Access Compliance Report

Public Rights-of-Way

(Curb Ramps)

Intersection ID: 14762	Main Street: E_TREMONT_AV	Cross Street: SPRINGDALE_AV	Location:	N
ADA ID: AE752D5DD658	Ramp Type: PerpDiag	Initial Pass/Fail: Fail	Overall Compliance: No	Severity Score: 13.75
Codes/Mitigation Info/Possible Solution		Field Measurements/Component Compliance

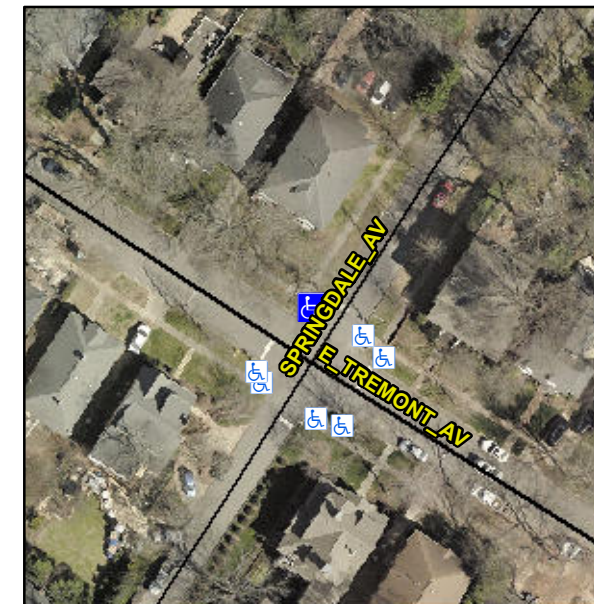
Not Found, R304.2.2, R304.5.3

Compliance	Description	Data	Compliance	Description	Data
N/A	Ramp Length (in)	92.0	No	Ramp Slope (%)	8.5
Yes	Ramp Width (in)	48.0	No	Ramp XSlope (%)	3.3
N/A	Flare Type LT	N/A	N/A	Flare Type RT	N/A
N/A	Flare Slope LT (%)	N/A	N/A	Flare Slope RT (%)	N/A
N/A	Flare Traversable LT?	N/A	N/A	Flare Traversable RT?	N/A
N/A	Landing Length (in)	N/A	N/A	DWS Provided?	N/A
N/A	Landing Width (in)	N/A	N/A	DWS Contrast?	N/A
N/A	Landing Slope (%)	N/A	N/A	DWS Length (in)	N/A
N/A	Landing X Slope (%)	N/A	N/A	DWS Full Width?	N/A
N/A	Landing Curb? (Y/N)	N/A	N/A	DWS Offset (in)	N/A
N/A	Shared Landing?	N/A			
N/A	Gutter Ponding?	Yes	N/A	Gutter Slope (%)	N/A
N/A	Gutter Lip Ht (in)	N/A	N/A	Gutter X Slope (%)	N/A
N/A	Painted X Walk1?	No	N/A	Painted X Walk2?	No
	X Walk 1 Direction	To SW		X Walk 2 Direction	To SE
N/A	X Walk 1 Width (in)	N/A	N/A	X Walk 2 Width (in)	N/A
	X Walk 1 Slope (%)	6.8		X Walk 2 Slope (%)	0.5
	X Walk 1 X Slope (%)	1.5		X Walk 2 X Slope (%)	0.1

Remove & Replace Curb Ramp With Two New Directional Ramps or Equivalent.
